GI-POF Link and VCSEL Reliability Calculations

Ramana Murty
Broadcom Inc.

Multi-Gigabit Automotive Ethernet over Plastic Optical Fiber
802.3dh TF Ad Hoc Meeting, October 19, 2022

Calculations reported in Refs. [1] and [2]

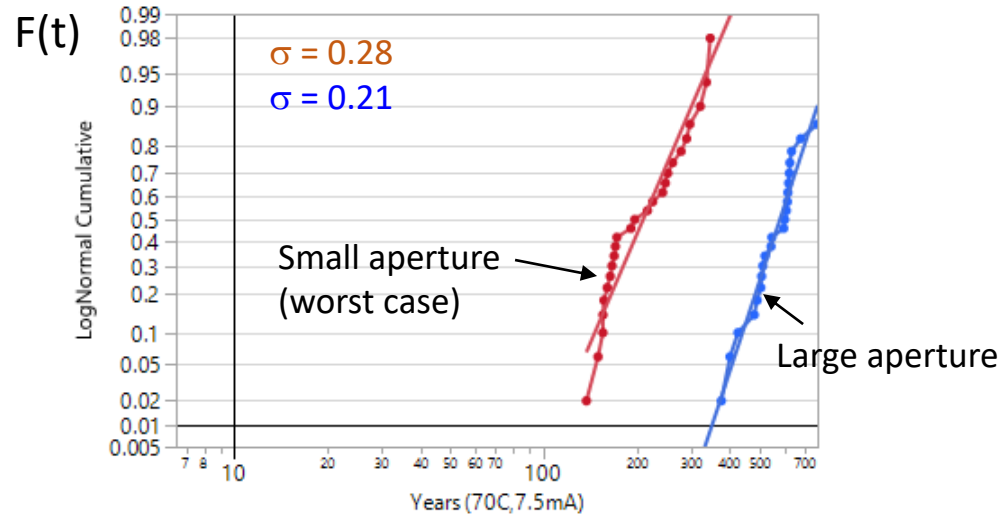
There are three main results here. There is agreement that two of the calculations are incorrect: ppm value and TTF_5 FIT.

The third, failure rate (= 118 FIT), is also incorrect and will be shown in the next several slides.

- a) Expression is not valid for wear out lognormal failure distribution.
- b) Vastly overstates failure.

Incorrect values even for the composite line.

$\lambda(t)$
118,4411
> 10 FIT !

Incorrect value

- The inputs to this calculation are incorrect.
- a) Calculated with an extrapolation of the composite line that leads to an incorrect answer.
 - b) This is calculated for Δt at 125°C (100%, not 1% as in the mission profile), see Appendix.

Extrapolate the Failure Distribution

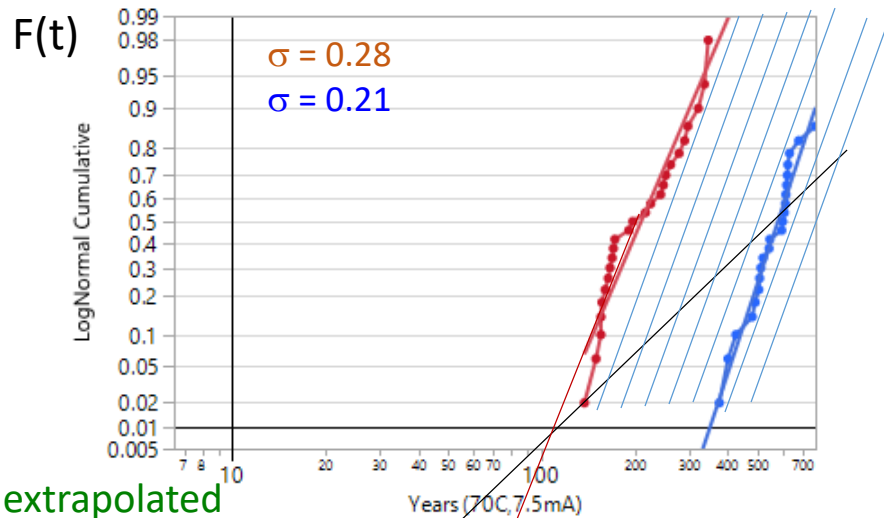
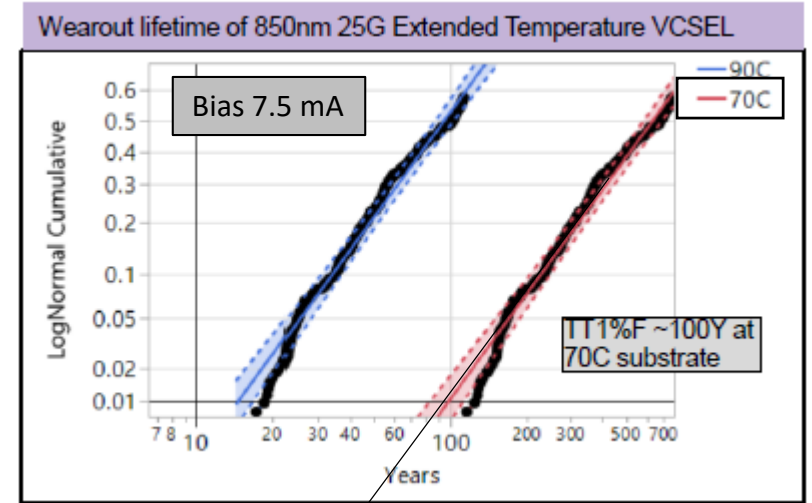
This section of the extrapolated line from the combined plot is above the orange curve (\Rightarrow the extrapolated portion is incorrect because it predicts higher failure than the orange line)

Failure cannot be higher than this line because it represents worst case.

This section of the extrapolated line for all 850 nm VCSELs is above the orange line and gives an incorrect value (too high) for failure.

- a) Extrapolated leftmost failure distribution. VCSELs do not fail to the left of this line because they are screened. [VCSEL aperture sizes don't follow a Gaussian distribution.]
- b) Failure will not exceed this line.

The extrapolated failure distribution for all 850 nm VCSELs lies above the orange curve! It vastly overestimates the failure rate. This is why the failure rate estimate (it is called hazard rate) is so high in Ref. [1].

Analysis in Ref. [1] punishes wide distribution of VCSELs

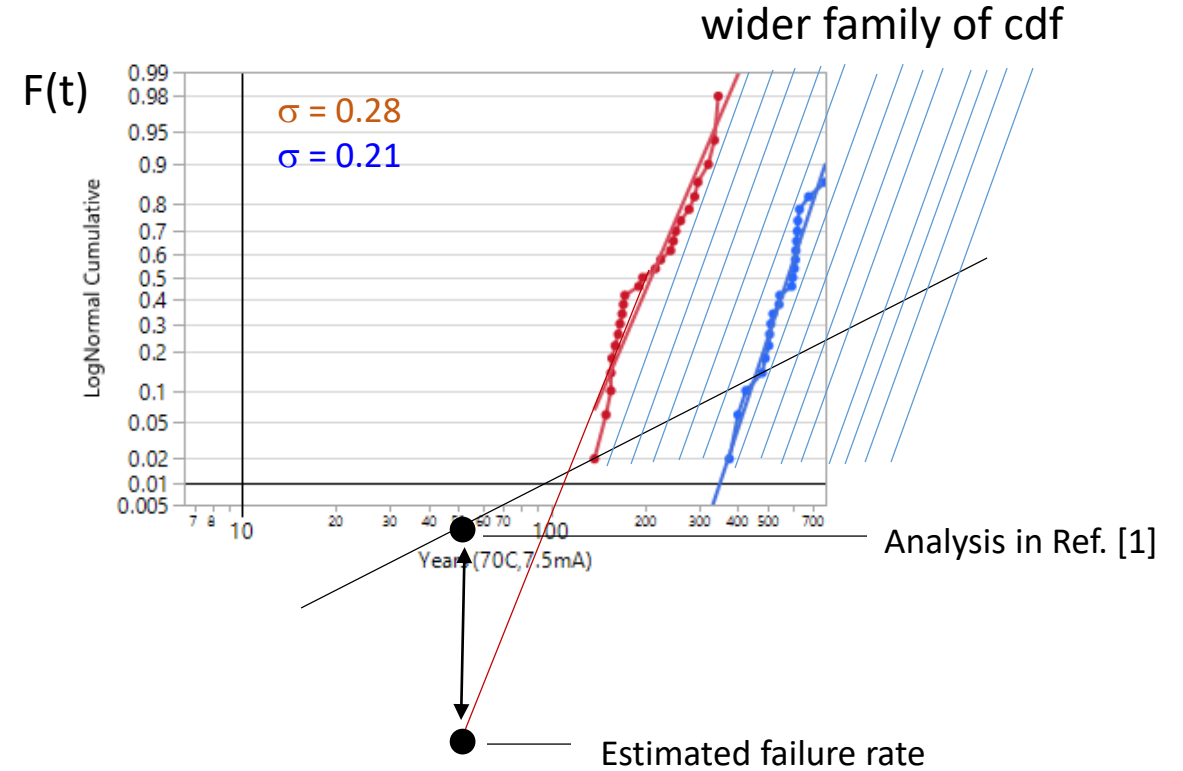
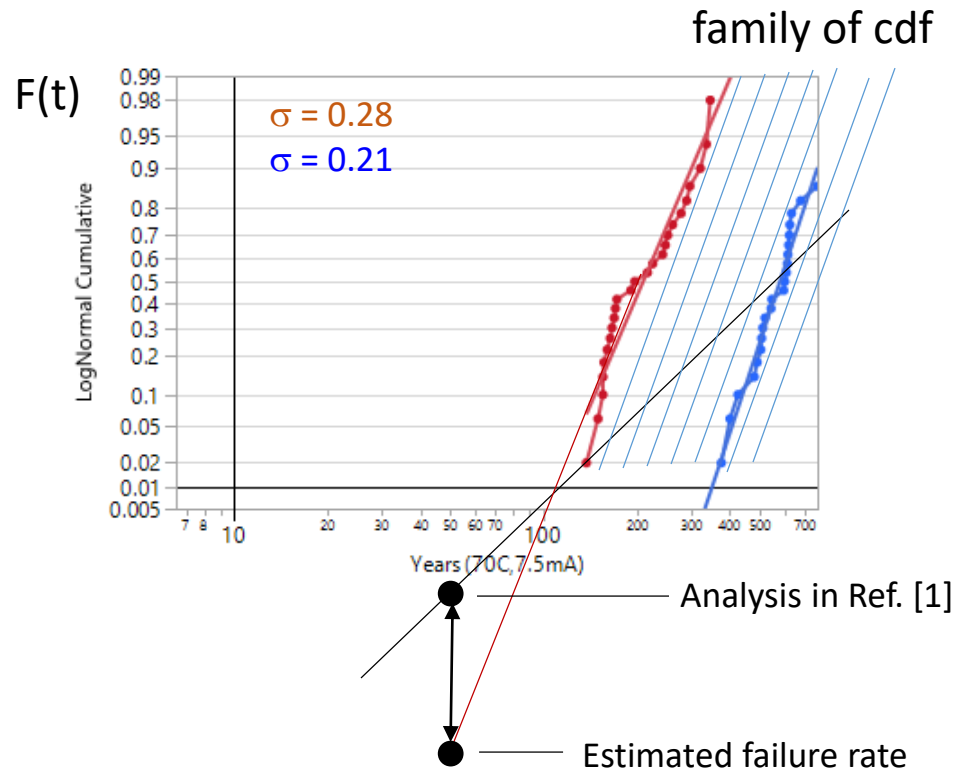
Predicted failure is higher for the wider distribution of VCSELs.

This does not agree with expectation that failure rate should not depend on the distribution of apertures (when worst case [orange line] is controlled).

Estimate for Hazard Rate for Wear Out

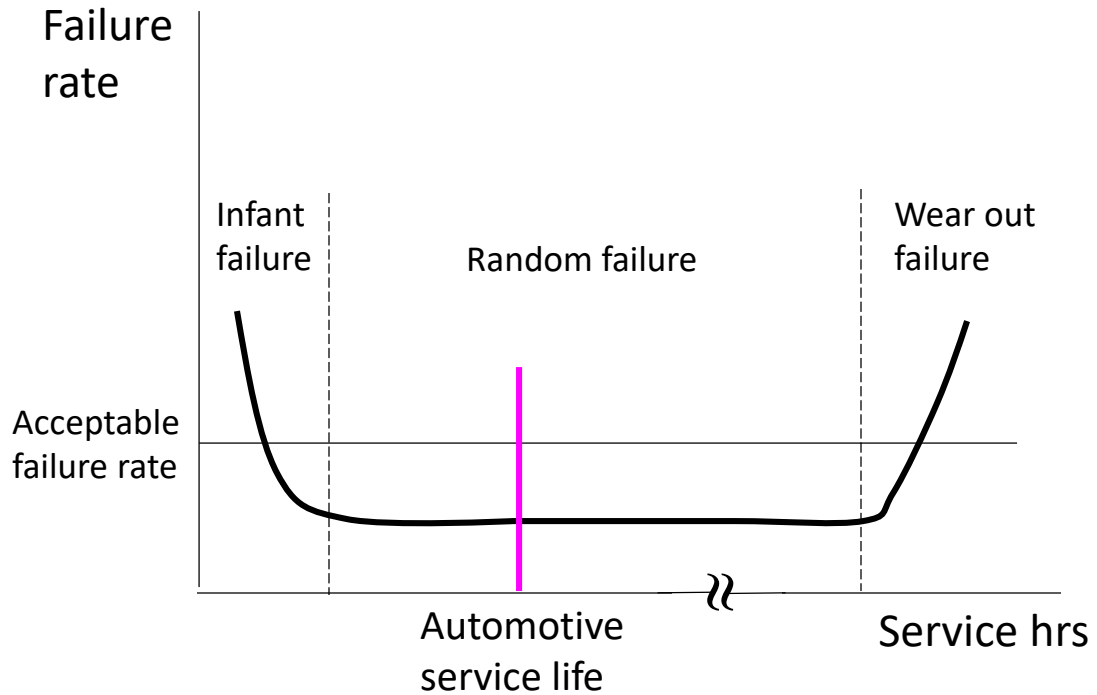
Bias	Item	Worst case VCSEL	Composite
7.5 mA	Hazard rate (FIT)	$\ll 1$	$\sim 100^*$

Invalid extrapolation

- **The hazard rate for wear out is very small**
- Hazard rate is the derivative of $F(t)$ [for $F(t) \ll 1$]

Failure Rate and Automotive Service Life

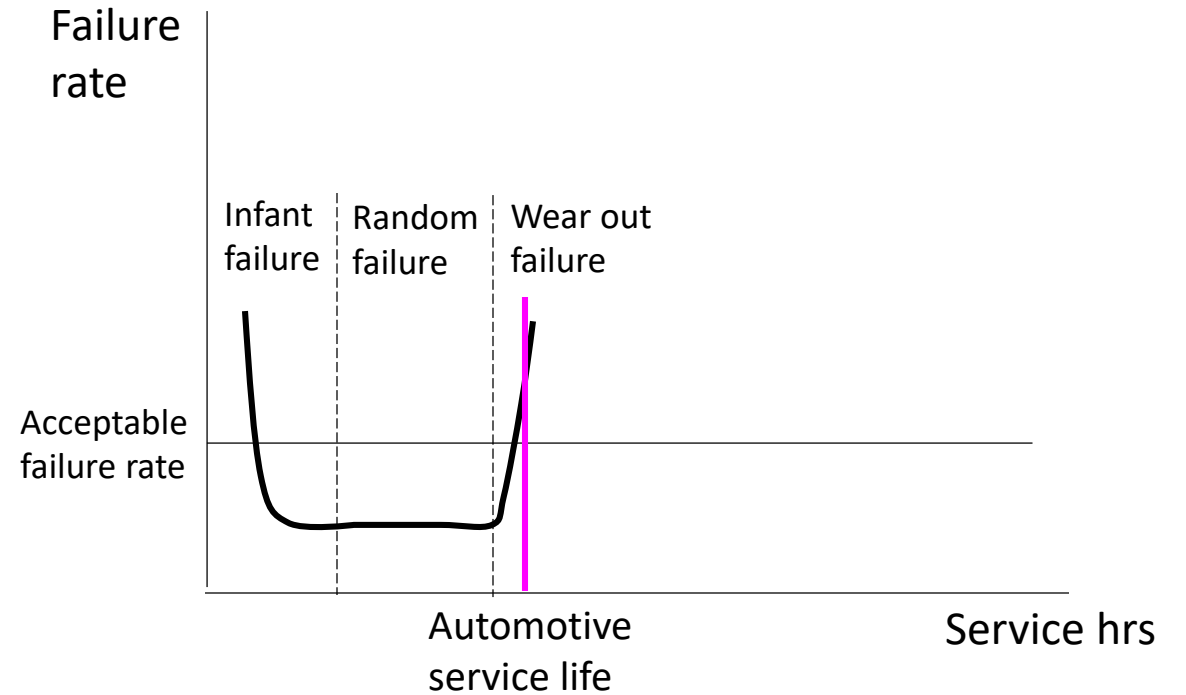
Claim in Ref [1]
This is incorrect.

Correct Picture
